Rezoning Application: PD 22-1703

Zoning Hearing Master Date: May 15, 2023

Applicant: The Widewaters Group, Inc.
FLU Category: UMU-20 & RES-6
Service Area: Urban
Site Acreage: 16.44 +/-
Community Plan Area: Brandon
Overlay: None
Request: Rezoning from PD to PD

Case Reviewer: Michelle Heinrich, AICP

Figure 2: Modified PD 05-0809

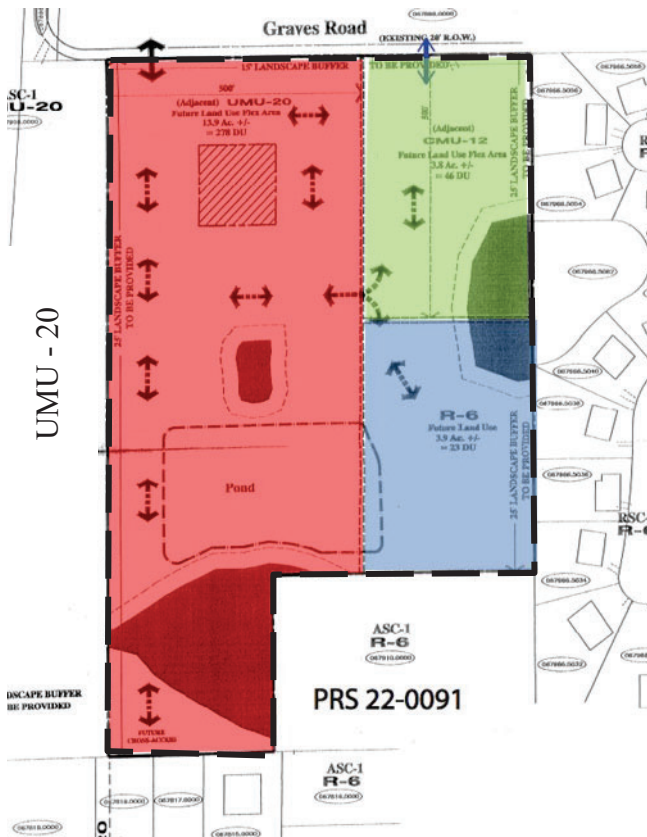
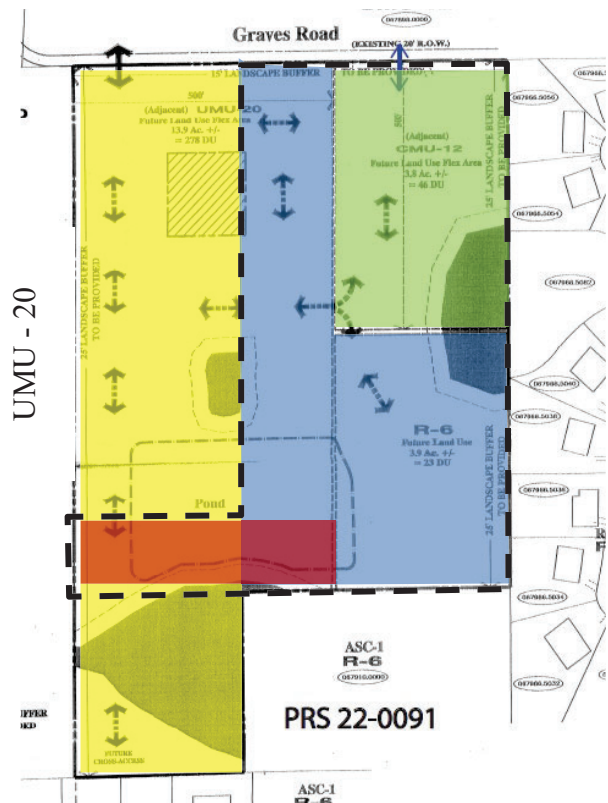
Figure 2 shows how PD 05-0809 will be modified due to the proposed rezoning. The area to be removed under this PD request is shown in yellow. The CMU-12 flex (shown in green) remains and is not impacted by the removal. In order to maintain the UMU-20 flex and the units it provides, a strip of land (shown in red) will remain connecting the UMU-20 FLU parcel to PD 05-0809. The remainder of PD 05-0809 will be within the RES-6 FLU category. The calculations are as follows: CMU-12 (3.8 acres) = 45 units, UMU-20 (0.95 acres) = 18 units, RES-6 (7.41 acres) = 44 units, totaling 107 units over the development area of 11.55 acres (9 units per acre). Additionally, the remaining area under PD 05-0809 has full access to Graves Road and is not dependent on the removed acreage for access.

8.0 PROPOSED SITE PLAN (FULL)

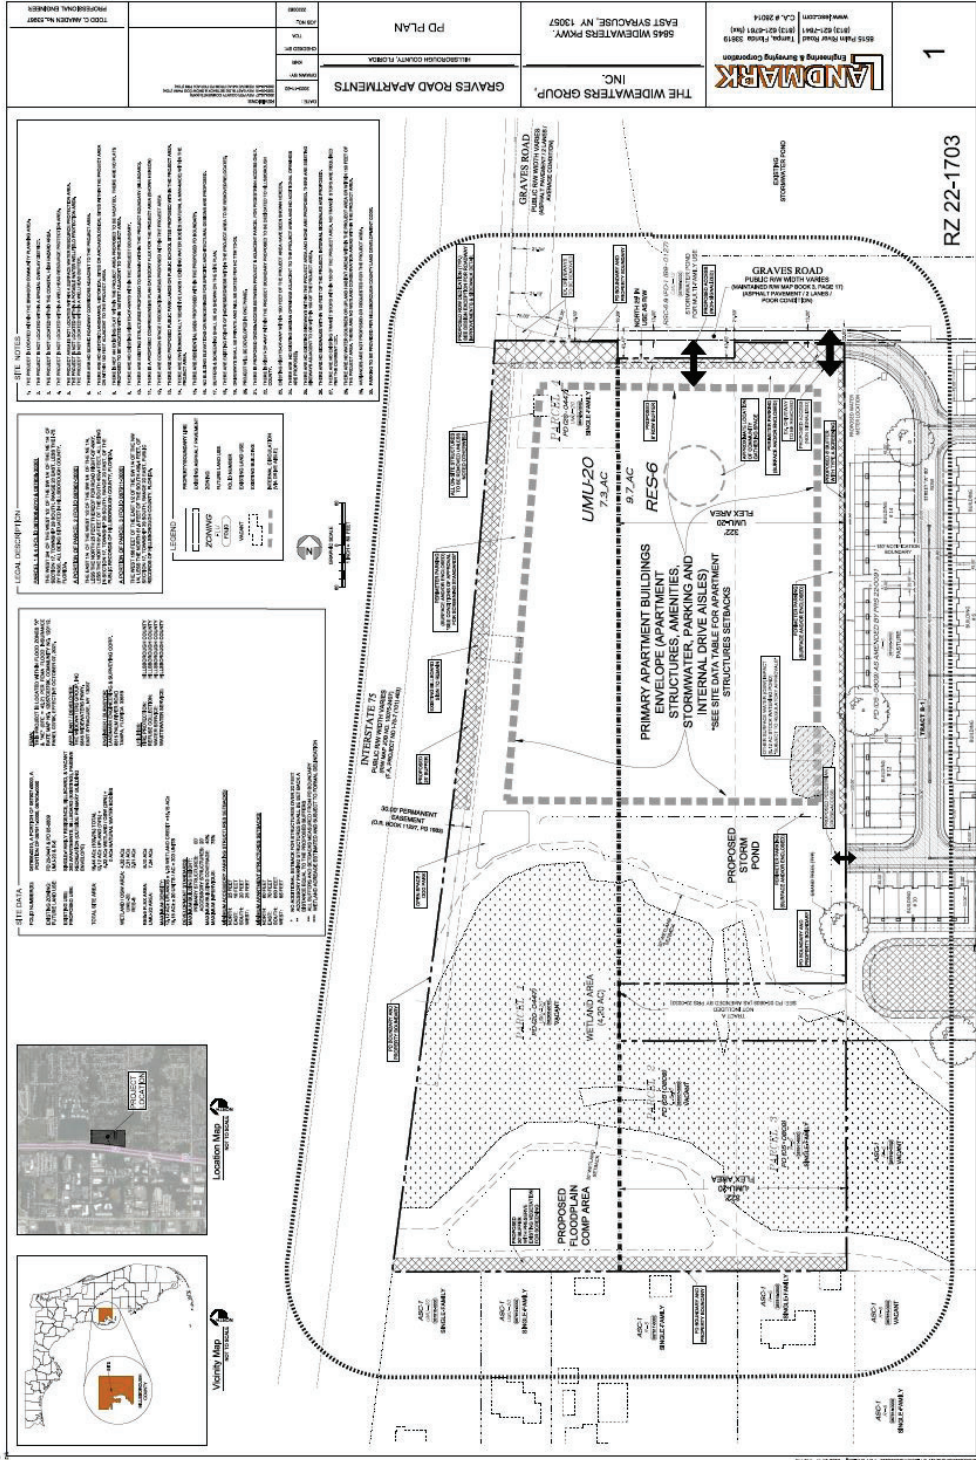
1. Site Data Table to correct the flex area from RES-6 to UMU-20.
2. Accessory structure southern setback to be revised – distance from PD boundary needed.
3. Site Plan to remove delineation and notation of existing billboard.
4. Correct RES-6 acreage on site plan from 9.7 acres to 9.1 acres.
5. Add a Note to the site plan that reads “Sidewalks to be provided per the Hillsborough County Land Development Code.”
6. Site Data table to remove “billboard” from existing use and proposed use.
7. The northern PD boundary buffer to be delineated using a different pattern than the eastern buffer.

Prior to PD site plan certification, the applicant shall revise the PD site plan to:

- Add a Note to the site plan that reads “Sidewalks to be provided per the Hillsborough County Land Development Code.”

**FIGURE 3. PROPOSED TYPICAL SECTIONS
GRAVES ROAD**

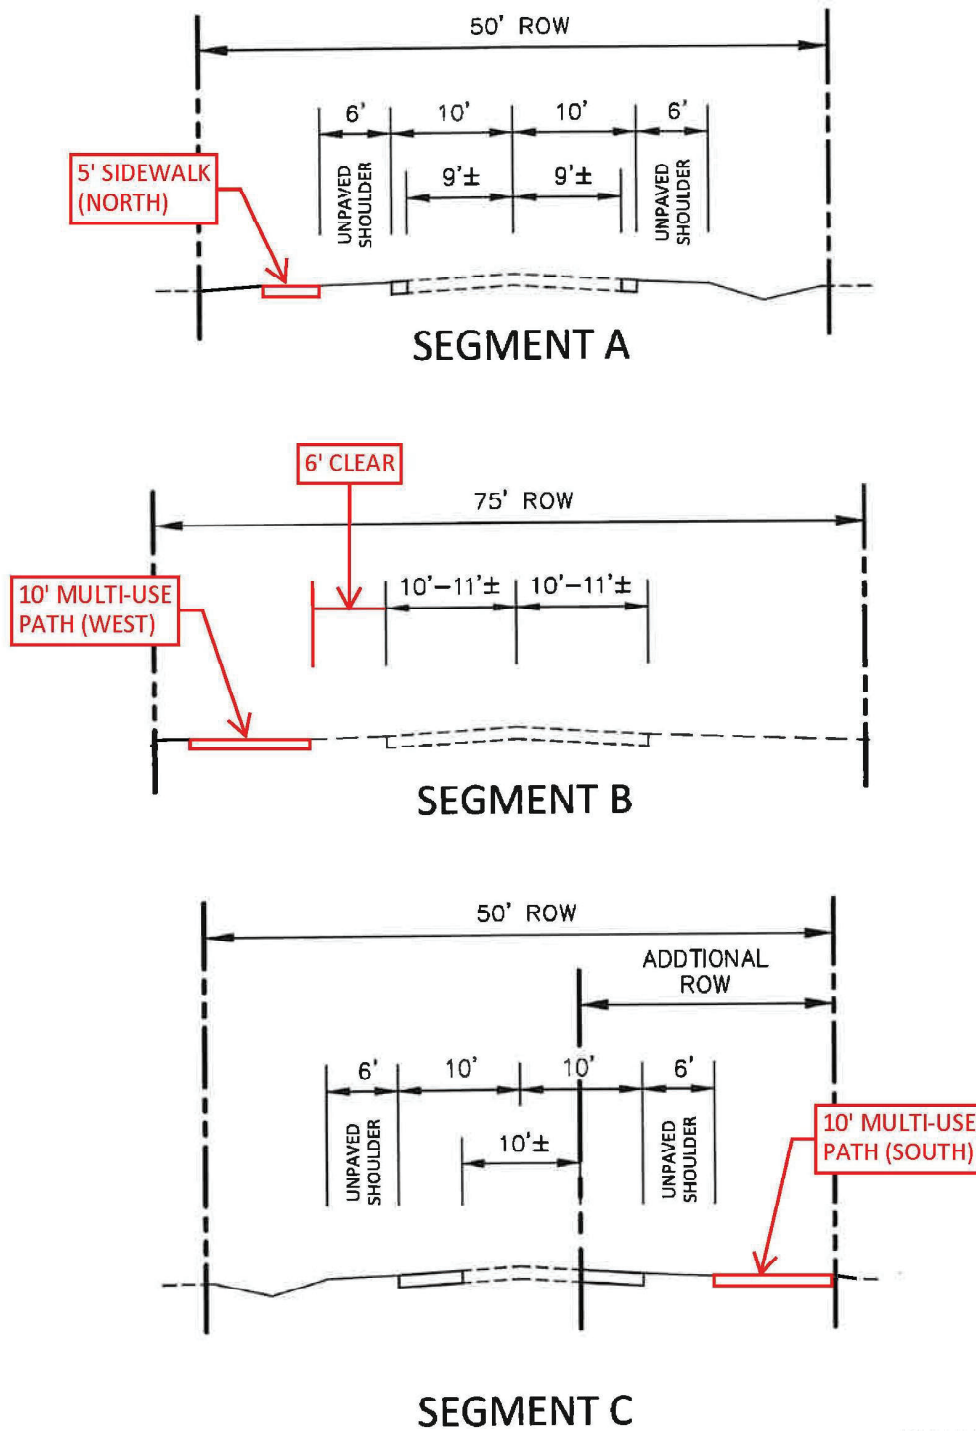
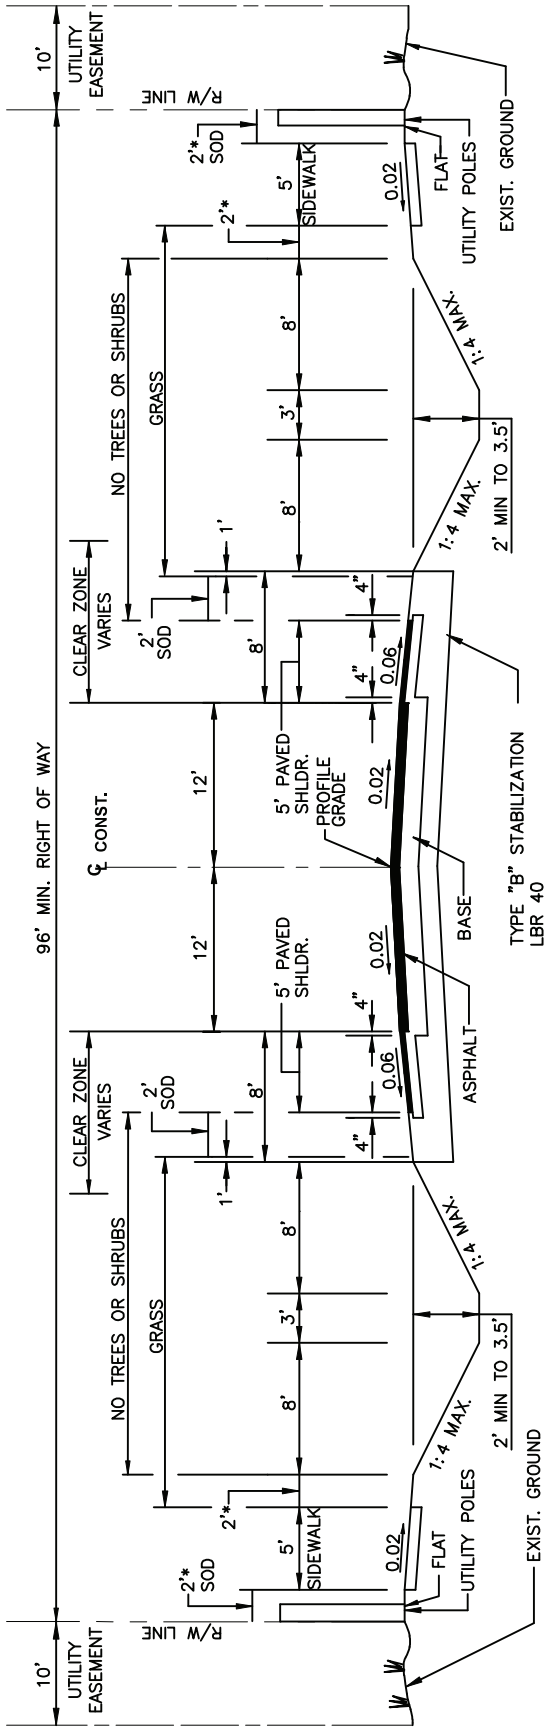
The attached Design Exception is approvable to me, please include the following people in your response:

1. Lane Width – TS-7 has 12-foot travel lanes. The existing lanes are approximately 9 feet. The proposed section has 10-foot travel lanes. This modification is currently under plan review PI 6103.
2. Shoulder – TS-7 has 8-foot shoulders with 5-foot paved on both sides of the roadway. The existing roadway has limited to no shoulders. Due to limited right of way, the full shoulder cannot be provided, however, a 6-foot unpaved shoulder is proposed to be provided on both sides of the roadway. This modification is currently under plan review, PI 6103.
3. Sidewalk – TS-7 has a 5-foot sidewalk on both sides of the roadway. Due to limited right of way, a 5-foot sidewalk is proposed on the north side of Graves Road. This will connect to the existing sidewalk along Broadway Center Boulevard.

1. Right of Way – TS-7 has 96 feet of right of way. The proposed right of way is 50 feet which will accommodate the proposed typical section.
2. Lane Width – TS-7 has 12-foot travel lanes. The existing roadway is approximately 10 feet. The proposed section has 10-foot travel lanes. This modification is currently under plan review PI 6103.
3. Shoulder – TS-7 has 8-foot shoulders with 5-foot paved on both sides of the roadway. The existing roadway has limited to no shoulders. Due to limited right of way, the full shoulder cannot be provided, however, a 6-foot unpaved should is proposed to be provided on both sides of the roadway. This modification is currently under plan review, PI 6103.
4. Sidewalk – TS-7 has a 5-foot sidewalk on both sides of the roadway. Due to limited right of way, a 10-foot multi-use path is proposed on the south side of Graves Road.
